RAI Volume 3, Chapter 2.2.1.3.13, First Set, Number 3, Supplemental Question 1:

RAI Volume 3, Chapter 2.2.1.3.13, First Set, Number 3, Supplemental Question 2:

RAI Volume 3, Chapter 2.2.1.3.13, First Set, Number 3, Supplemental Question 3:

Supplemental Figure 1. Ash Density and Waste/Ash Mass Ratio at Three Distances Downwind from the Volcanic Vent for Realization 316

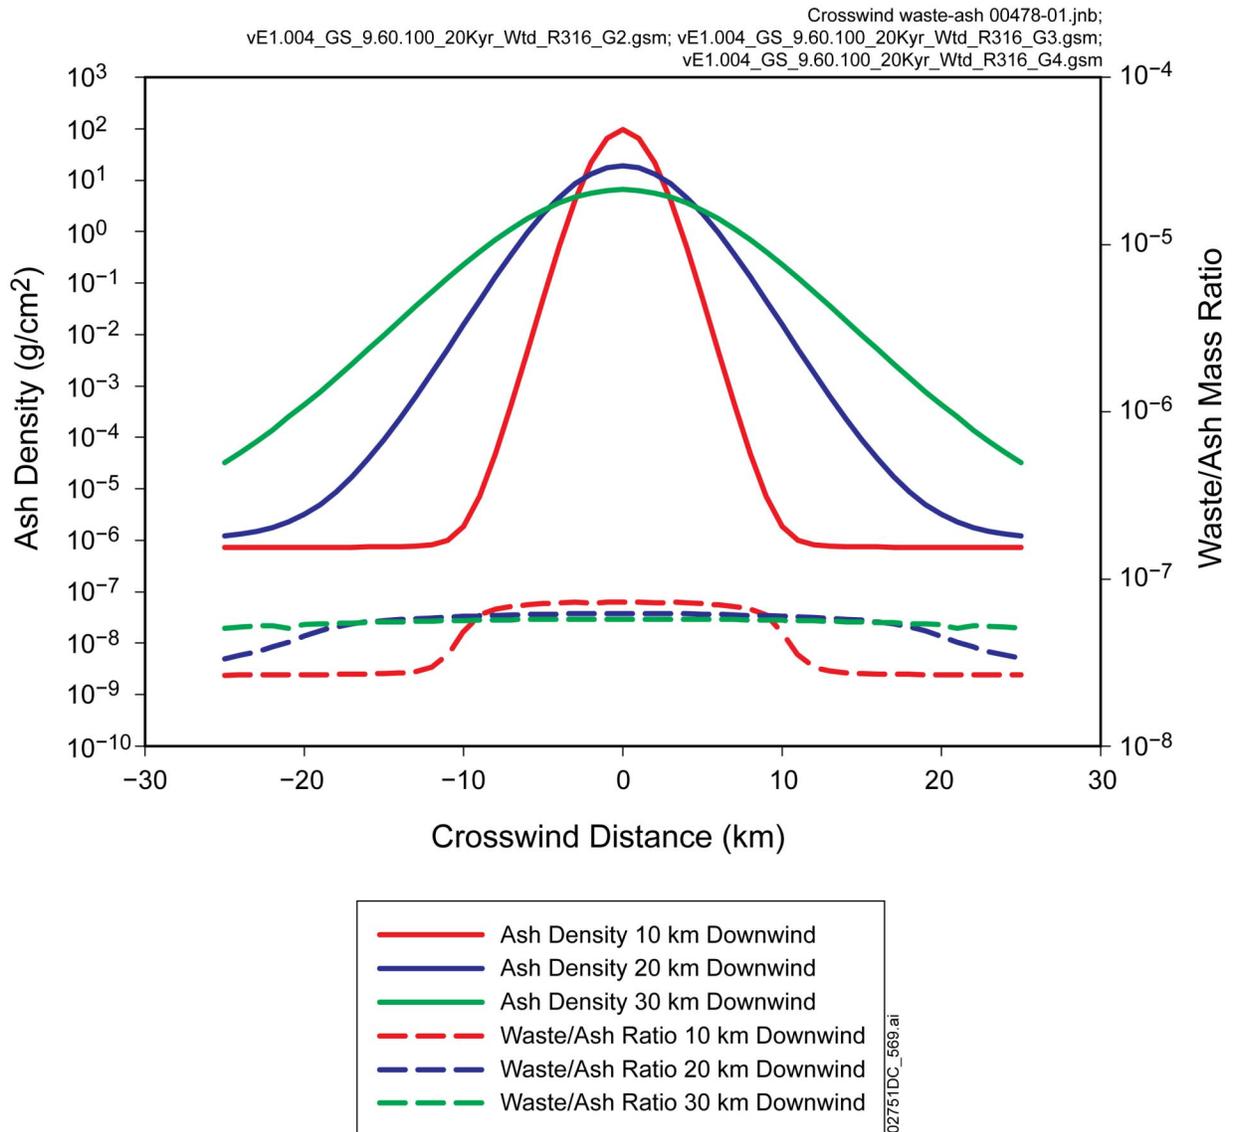
In the model realization output shown in Figure 1 in the original response to RAI 3.2.2.1.3.13-003, the mass per unit area (ash density) along the dispersal axis is essentially the same 10, 20, and 30 km from the vent. This is not normal for tephra deposits, which will decrease in thickness (mass per unit area) over such distances, and requires an explanation. If this result is an artifact of using the sub-15 μm mean particle size (Table 1 in the response to RAI 3.2.2.1.3.13-003) for this particular realization, then justification for the use of such small particle sizes, which are not appropriate for the Suzuki model (Suzuki 1983), should be clarified. What proportion of realizations in TSPA used output from such small grain size tephra distribution? What proportion of realizations used a 30 μm mean particle size or less?

The mean tephra particle diameter for the TSPA volcanic eruption model is sampled from a log-triangular distribution with a minimum of 0.001 cm, mode of 0.01 cm, and maximum of 0.1 cm. Justification of this particle size distribution is discussed in *Characterize Eruptive Processes at Yucca Mountain, Nevada* (SNL 2007, Section 6.3.5.1). This distribution of particle sizes results in approximately 1.6% of realizations using a mean particle size less than 0.0015 cm and approximately 11.4% of realizations using a mean particle size less than 0.003 cm. As shown in Table 1 of the original RAI response, the mean particle size used for the realization selected for the demonstration of the variation of the waste/ash ratio, 0.001451 cm, was near the lower end of the mean particle size distribution.

The ash density along the dispersal axis is represented by the peak of the curves at crosswind distance equal to zero in Figure 1 of the original RAI response. The peak values of ash density shown in the figure vary from 0.1325 g/cm^2 at 10 km downwind, to 0.1931 g/cm^2 at 20 km downwind, to 0.1558 g/cm^2 at 30 km downwind. This variation represents an increase of 46% from 10 to 20 km followed by a decrease of 19% from 20 to 30 km. The amount of change in these peak values is not solely an artifact of the relatively small mean particle size. The ash density shown in the figure is influenced by particle size, but also by other eruptive parameters, including wind speed and eruption power.

A second realization, with a larger mean particle size, was selected for comparison to the data in the original RAI response. ASHPPLUME parameters for realization 316 are shown in Supplemental Table 1 and the ash density and waste/ash ratio curves are plotted in Supplemental Figure 1. As shown in Supplemental Table 1, the mean ash particle diameter in this realization is 0.0251 cm. As with realization 5, the magma-partitioning and decay factors are not used for the supplemental results shown here. In realization 316, ash density decreases by an order of magnitude along the dispersal axis. Tephra concentrations for additional ASHPPLUME realizations are shown in Figure 2 of the response to RAI 3.2.2.1.3.13-004. The variation in ash density along the dispersal axis is greater in realization 316 shown in Supplemental Figure 1 than in realization 5 shown in the original Figure 1 due to the larger mean ash particle size and differences in other eruption parameters shown in Supplemental Table 1. The waste/ash ratio

shows similar relative variations in realizations 5 and 316. The magnitude of the ratio is significantly less in realization 316 than in realization 5 because the much longer eruption duration in realization 316 results in more erupted ash mass while the erupted waste mass remains constant.
